S-SB-0023-12

Abnormal Chirp or Squeak Noise from High Pressure Fuel Pump

YEAR(S)	MODEL(S)	ADDITIONAL INFORMATION
2013	FR-S

Figure 1.

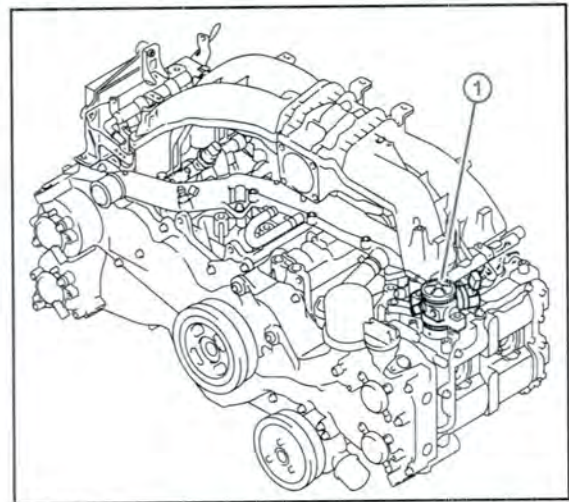
Some vehicles may exhibit a high pitch chirp or squeak noise from the High Pressure Fuel Pump Assembly when the engine is fully warmed up and idling. Follow the procedure in this bulletin to address this condition.

- Road test the vehicle for at least 10 minutes so that the engine is fully warmed up.
- While the engine is idling, listen for abnormal noise from the High Pressure Fuel Pump Assembly.

- A mechanical ticking noise from the High Pressure Fuel Pump Assembly is normal during Direct Injection system operation.
- This bulletin should only be performed if an abnormal high pitch chirp or squeak noise from the High Pressure Fuel Pump is verified.

Does the vehicle have an abnormal chirp or squeak sound from the High Pressure Fuel Pump Assembly?

4. Replace the High Pressure Fuel Pump Assembly.
